Re: Taylor Avenue Reconstruction
Main Street Pedestrian Improvements
Design Criteria Recommendations
Project No. 24-0060

This letter is an update to Town Council for the Taylor Avenue capital improvement project. Two meetings were held to allow the Taylor Street residents the opportunity to discuss concerns regarding the resurfacing of Taylor Avenue. The first was the September 18, 2024 Town Council Meeting and an Open House held at Town Hall on January 9, 2025. There were approximately 15 residents who attended the open house and Cindy Krieg (Economic Development/Deputy Clerk) heard from several residents after the Open House meeting.

Street would move
into Tract C

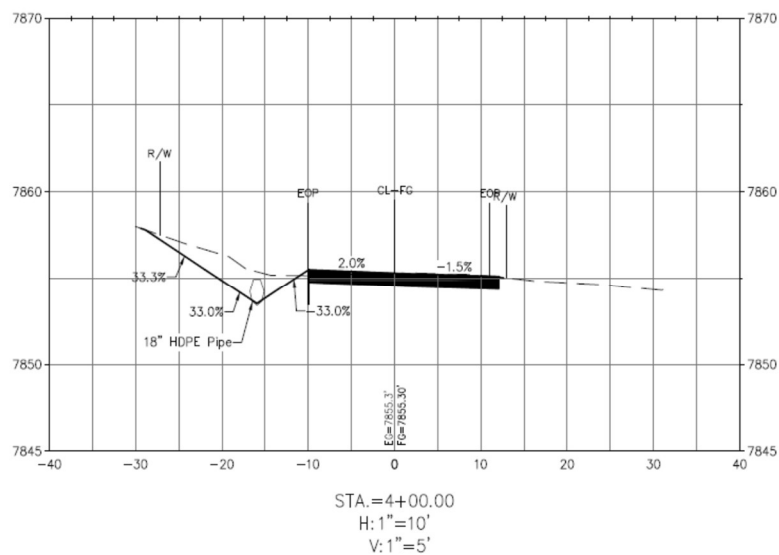
Residents pointed out Building C of the Minturn Towne Homes is too close to the Taylor Avenue pavement. The driveways are short and large vehicles parked in the driveway encroach into traveled way. They suggested moving the pavement north into the Town's Parcel C to be able to lengthen the driveways.

- Relocating the asphalt will require widening the right of way into Parcel C. The ground surface falls off steeply at the edge of the pavement and moving the roadway will require extensive fill material and regrading.

The Town needs to decide if they want to allow the encroachment into Parcel C and incur the additional reconstruction costs.

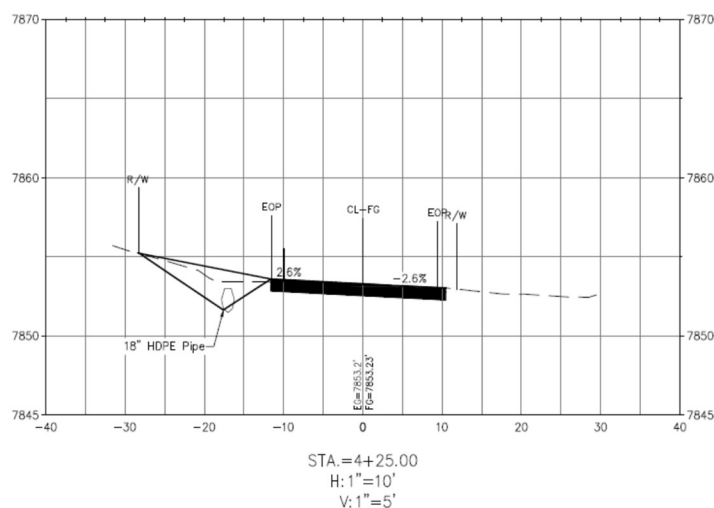
Residents would like to preserve on-street parking on the east side of Taylor and felt a ditch or shallow swale would preclude parking. A drainage ditch will preclude parking and require culverts to be installed under each driveway. A sample cross section is shown below.

We need guidance from the Town on the preferred roadway section and drainage improvements.

"Hump" is located
at the Lions Lane
intersection.

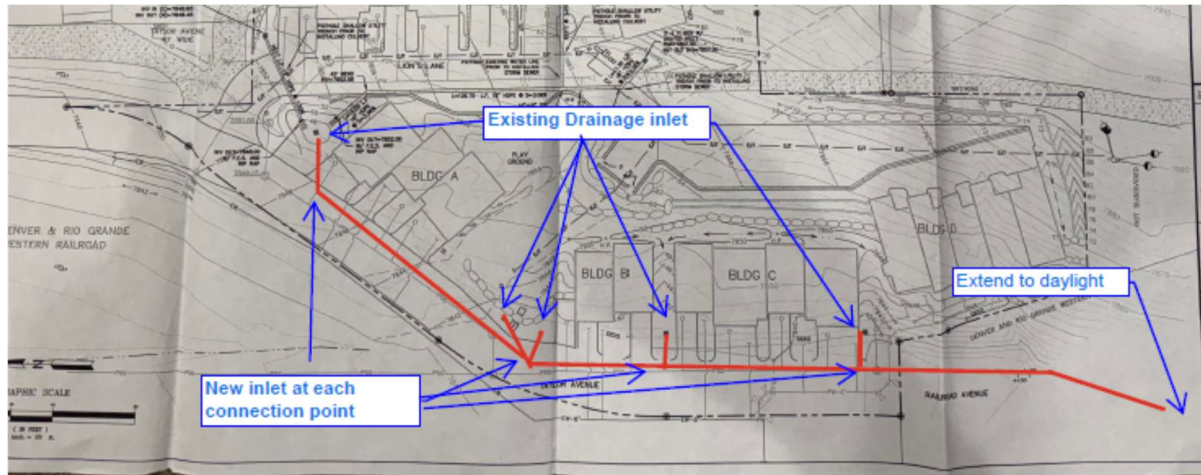
The residents are concerned about the profile of Taylor Avenue near the intersection of Lions Lane. There is a roadway crest ("hump") in the road at the intersection that reduces the driver's sight distance. It was suggested to either lower or raise Taylor Avenue north of this area. Lowering the roadway crest will increase the slope of Lions Lane and is not a good solution. We are told vehicles slide through their stop sign at Taylor Avenue now and a steeper slope will exacerbate the current problem. Neighbors suggested adding fill to the north side of the crest area. The placement of additional fill material would need to be analyzed to assure it does not interfere with access to existing driveways.

Action Item:
The Town needs to consider the request and provide direction.
